SERVICE BULLETIN

M1525 2021-05-03

M1525: 2021 PAN AMERICA - FAIRING LOWER RUNNING CHANGE

Figure 1. Pan America Running Change (Right Shown, Left Similar)

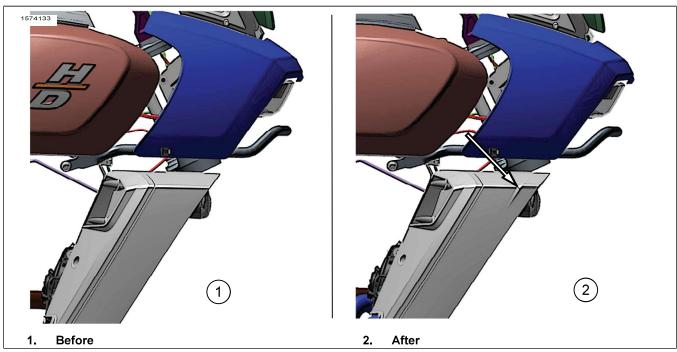
Is to inform dealers that there has been a running change to the 2021 Pan America fairing lowers. The only service replacements offered are the revised version of the fairing lowers. If a cosmetic issue is discovered during Predelivery Inspection (PDI), order and replace both left and right fairing lower components. The replacement of both components only applies to vehicles built before the running change.

If a cosmetic issue is discovered to the lower fairings at PDI, or a warrantable issue is seen during the warranty period, then replace both left and right side components. File the appropriate warranty claim. If one of the lower fairings is replaced as a non-warrantable concern, replacement of the opposite side would be non-warrantable as well.
